**Doc. No.: HUS-CEA-ED-LTR-00008**

**Subject: Response to Husky Energy Exploration Drilling Project – Round II Information Requirements.**

**Husky Exploration Drilling Project:  
Response to Round 2 Information  
Requirements from Environmental  
Impact Statement Review**

**ED-HSE-RP-0040**

**Figure 1 Phase Speed (solid lines) and Group Speed (dashed lines) of Tsunami Waves on a Flat Earth Covered by Oceans of 100 m to 6 km depth (top). Wavelength Associated with Each Wave Period (bottom)**

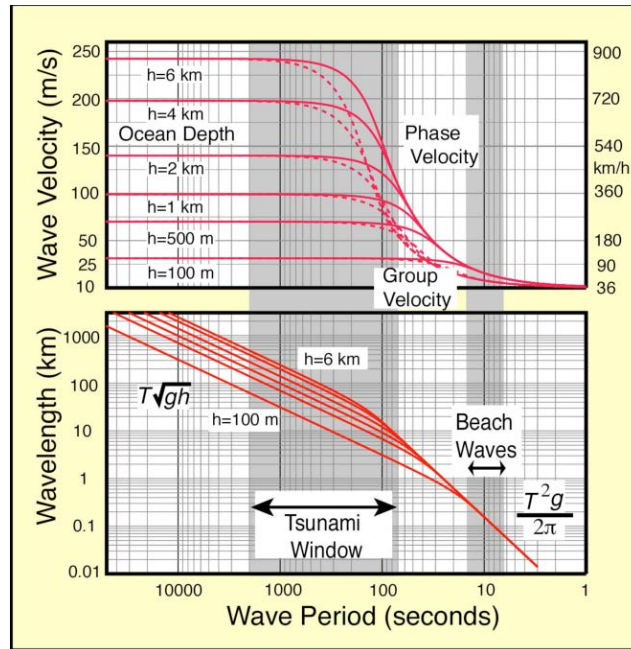
Discuss whether a tsunami wave would break on the relatively shallow waters of the Grand Banks and describe how much the wave could potentially grow in height and narrow in width.

Provide a discussion on measures taken to minimize the impacts of a tsunami on the project infrastructure within engineering design plans.

where  $g$  is the acceleration due to gravity ( $9.8 \text{ m/s}^2$ ) and  $H$  is the depth of water. Depending on the wave depth, tsunami waves can travel at 160 to 250 m/s (Figure 1). In the open ocean, tsunami waves have a wavelength of 10 to even 100 km (Figure 1). Tsunami wave height in the open ocean is imperceptible and smaller than 1 m.

Figure 1 Zone of Influences from Permanent Light Sources in the Project Area (assuming a 16 km radius from light source)

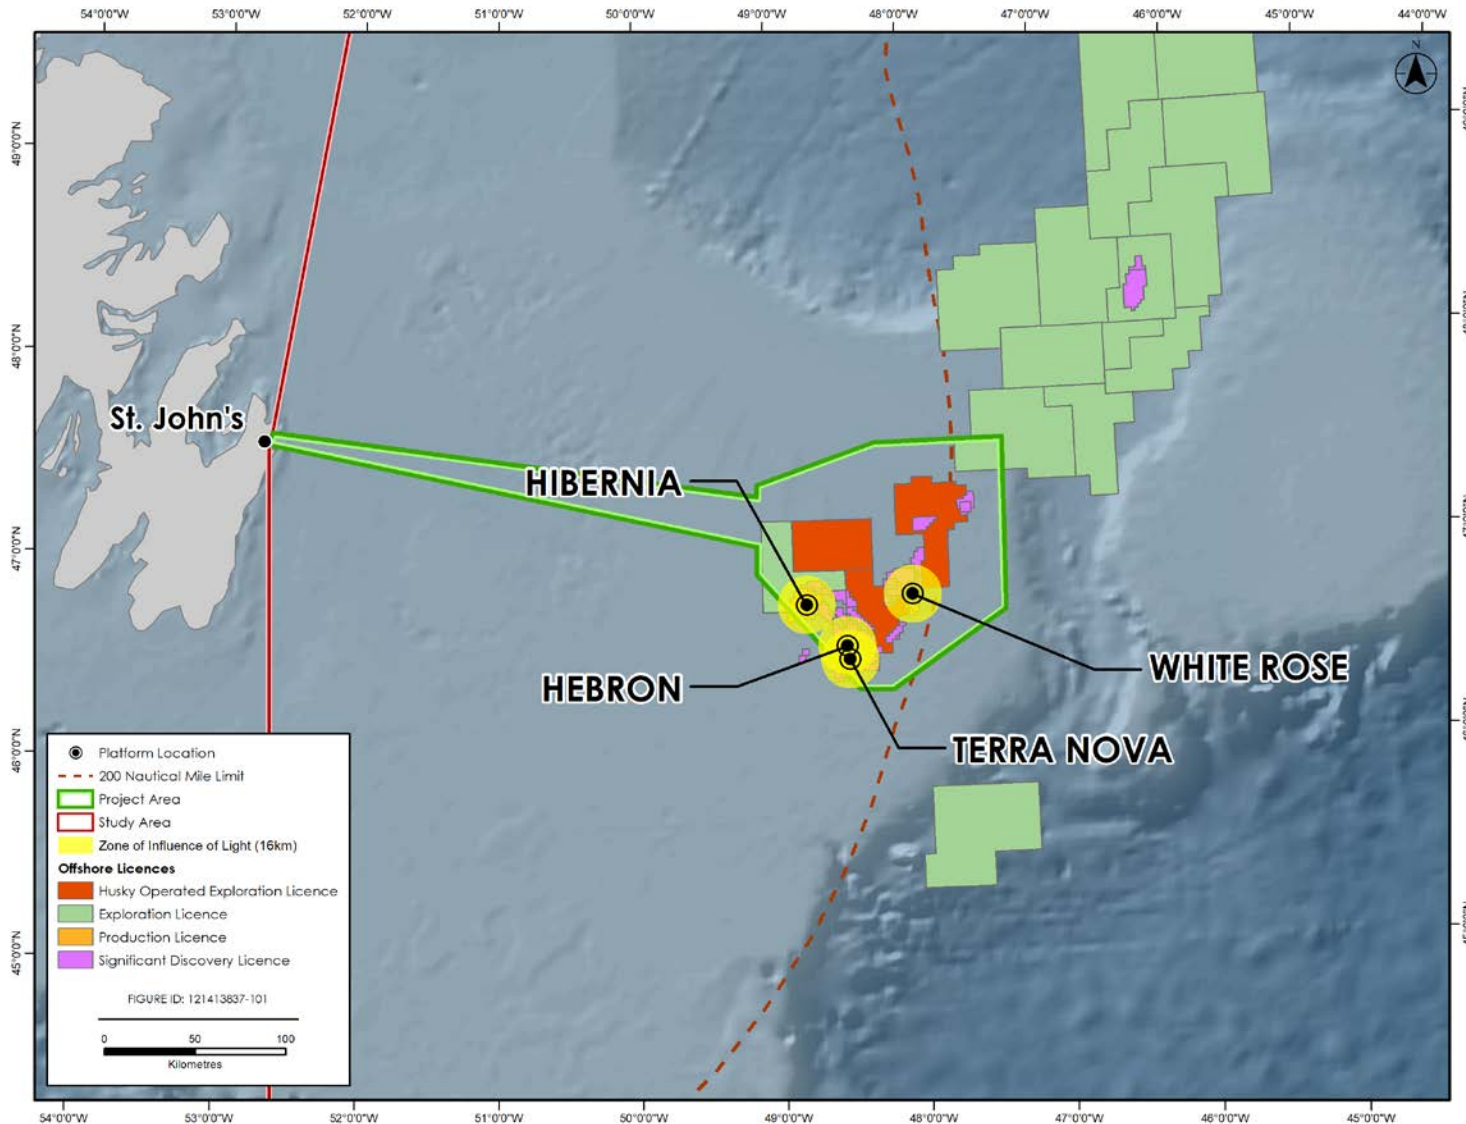
Provide information to support the statement related to the contribution of light from the Project to the area.

Provide information to support the statement that the distance between projects operating in the Newfoundland and Labrador offshore would allow birds to pass between projects without being influenced.

Figure 1 illustrates the zones of influence (ZOI) of light created by existing production platform locations within the Study Area, which include Hibernia, Hebron, Terra Nova and White Rose. It has been noted that lighting attraction effects are anticipated to be confined to within approximately 5 km (Poot et al. 2008) to 16 km (Rodríguez et al. 2014, 2015) of the source. For the purpose of Figure 1, the largest anticipated ZOI (16 km) was used.

The previous IR response indicated that birds could pass between projects without being influenced by the artificial light produced by offshore exploration activities. Based on Figure 1, this is currently true for some of the current platforms. A migrating bird could currently pass between White Rose and any other platform,

It is also important to note that oil and gas exploration and production activities are not the only sources of artificial light in the offshore environment; fishing fleets and cargo vessels are other mobile sources. These are not shown in Figure 1, as they could occur throughout the Project Area at any time.
